MEMORANDUM

RE: Recommendations on the Phase I Site Plan  
Review; Submission 1, May 12, 2008

## Wayland MUOD Phase I Site Plan Review

RE: Phase I Site Plan I Engineering Review  
Wayland Town Center  
400 Boston Post Road

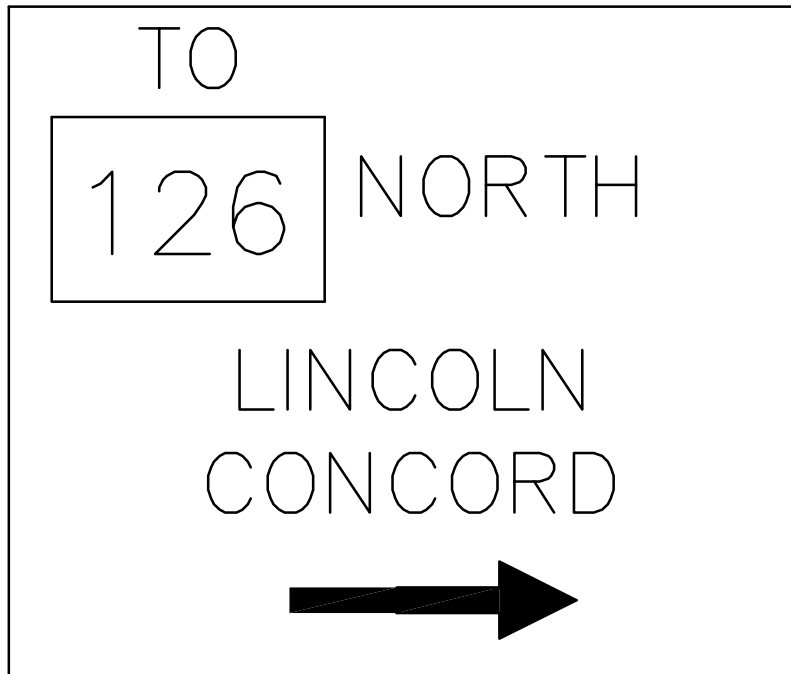
11. The off-site wayfinding signs for vehicles leaving the site bound for Route 126 North should be shown on Sheet C-5B or L9.0. These signs may be part of the off-site improvement plans, but referenced on this plan set as it affects traffic leaving the site as part of the Site Plan review. A sample guide sign is provided as an attachment to this letter.
